APPROVED BY: CIVIL UTILITIES ENGINEER - WATER		ALBERT A. WEBB ASSOCIATES CIVIL ENGINEERS RIVERSIDE, CALIFORNIA		APPROVED BY: CITY ENGINEER R.E. NO. 9876		CITY OF RIVERSIDE, CALIFORNIA DEPARTMENT OF PUBLIC WORKS		SEWER PLAN AND PROFILE CITRUS STREET SEWER EXTENSION		PROJECT NO. S-733	
DATE: 11-2-68		DATE: 10/19/68		DATE: 11-27-68		DATE: 11-27-68		R/S 1055 PARCEL 7		SHEET 1 of 1	
DESIGNED BY: R.E.		DRAWN BY: R.E.		CHECKED BY: R.E.		DATE: 11-27-68		HORIZ. SCALE: 1" = 50'		VERT. SCALE: 1" = 5'	
								FILE NO. 68-263

APPROVED BY: <i>Howard K. Carson</i> 11-12-68 CHIEF UTILITIES ENGINEER - WATER	ALBERT A. WEBB ASSOCIATES CIVIL ENGINEERS RIVERSIDE, CALIFORNIA APPROVED BY: <i>Edward N. Webb</i> DATE 11/15/68 R.E. No. 9876	CITY OF RIVERSIDE, CALIFORNIA DEPARTMENT OF PUBLIC WORKS APPROVED BY: <i>W. H. [Signature]</i> DATE 11/17/68 OFFICE ENGINEER PARK DEPARTMENT TRAFFIC DIVISION ASSISTANT CITY ENG.	APPROVED BY: <i>[Signature]</i> DATE 11/17/68 DIRECTOR OF PUBLIC WORKS	PROJECT NO. S-733
				SHEET 1 OF 1 FILE NO. 68-263

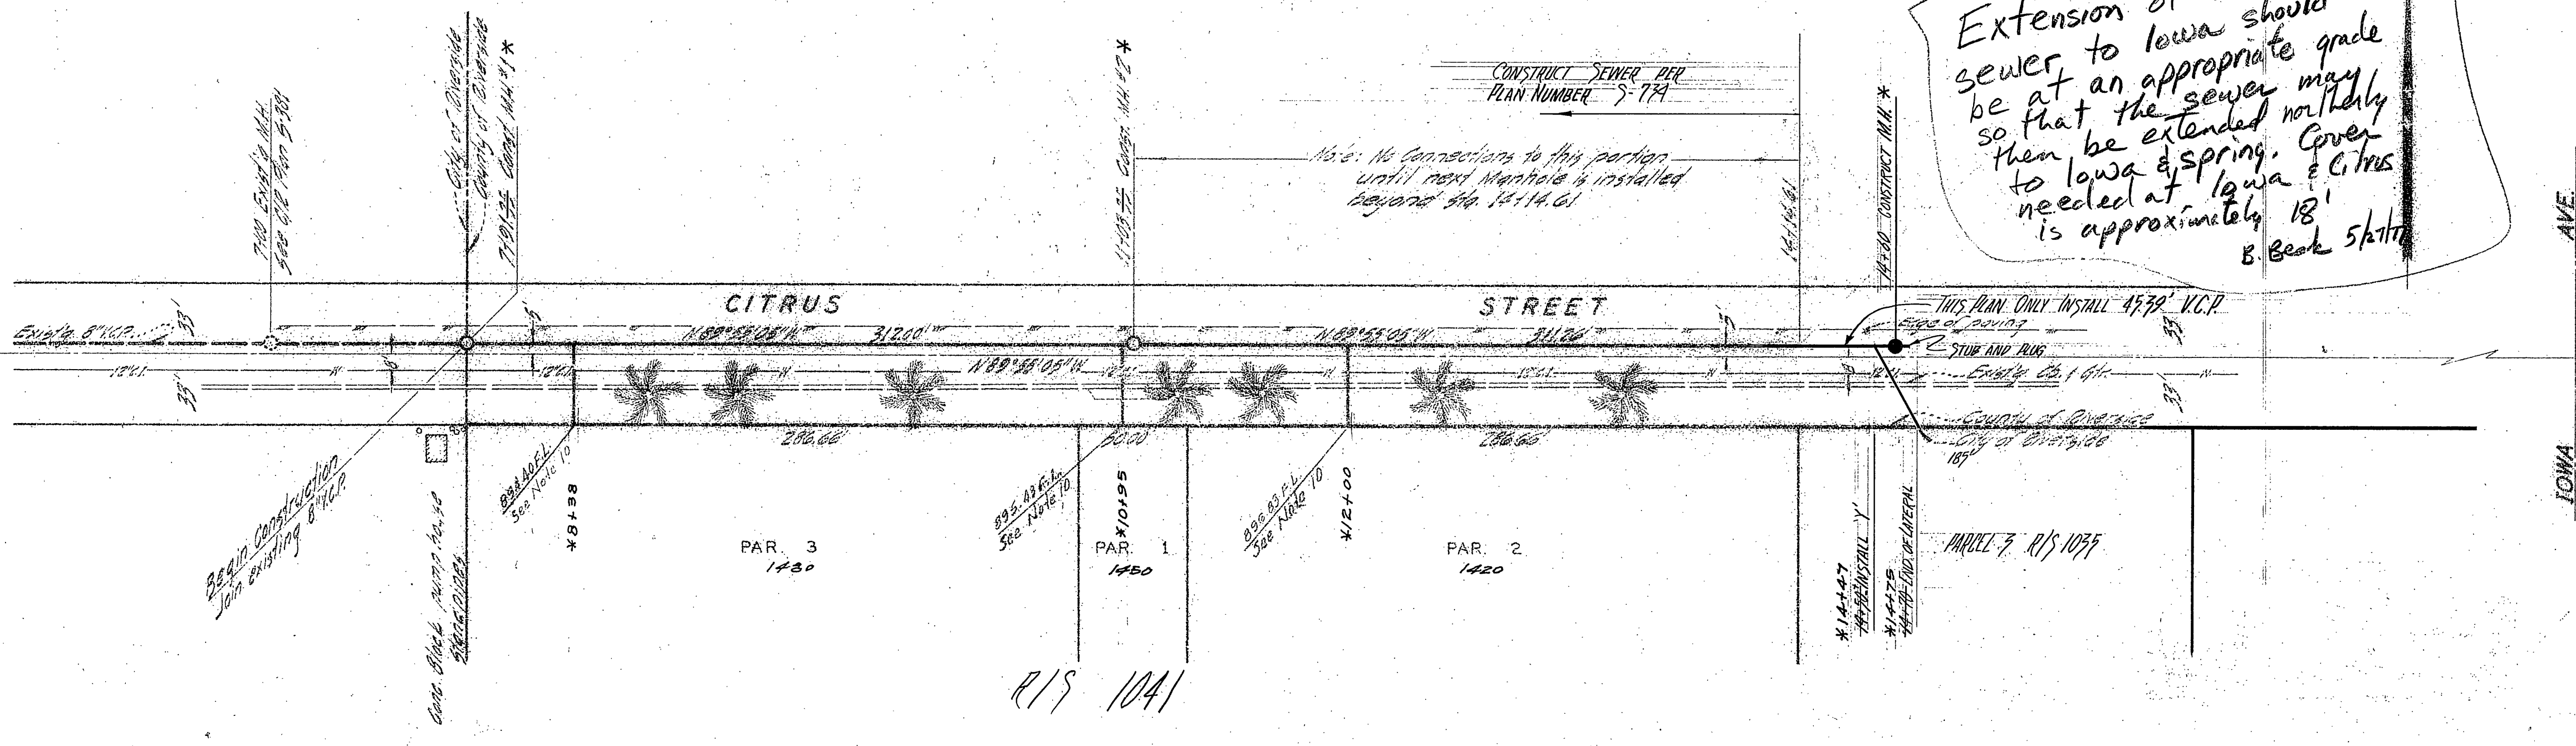
Extension of this sewer to Iowa should be at an appropriate grade so that the sewer may then be extended north to Iowa & Spring. Cover needed at Iowa & Citrus is approximately 18' B. Beck 5/1/77

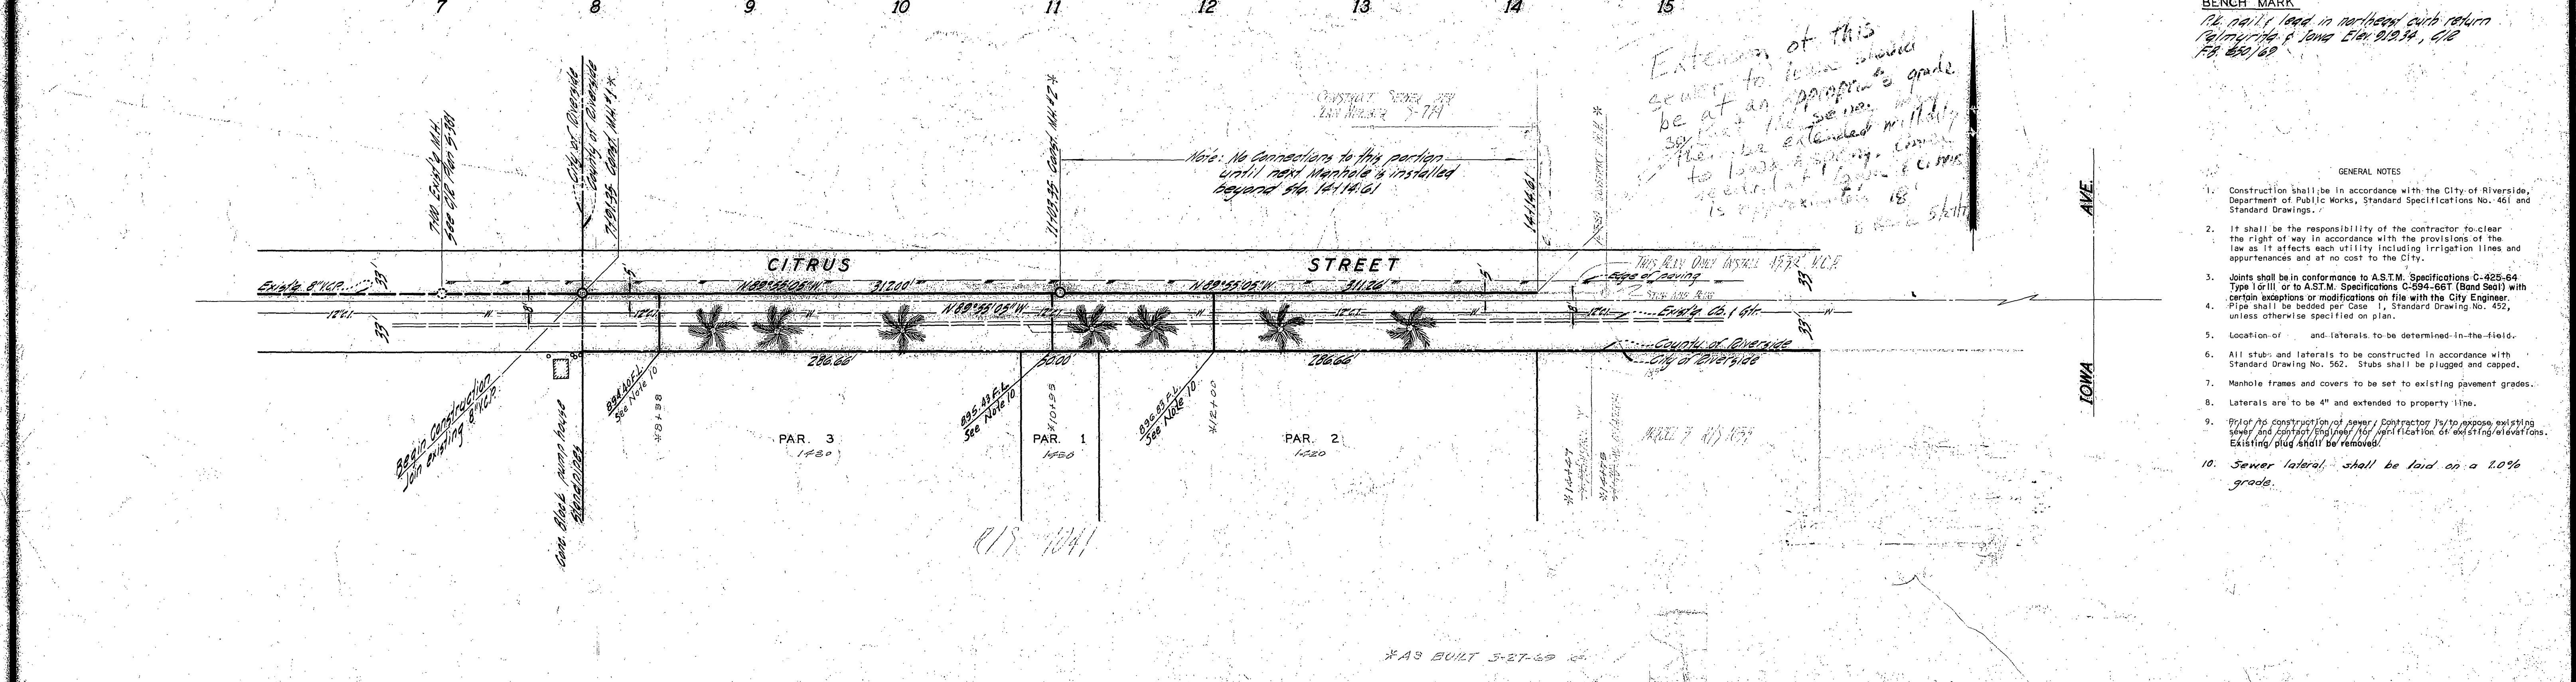
Extension of this sewer to lower grades be at an appropriate grade so that the sewer there be extended with ability to load a spring. Current depth at 14+00 is approximately 18' to 20' depth.
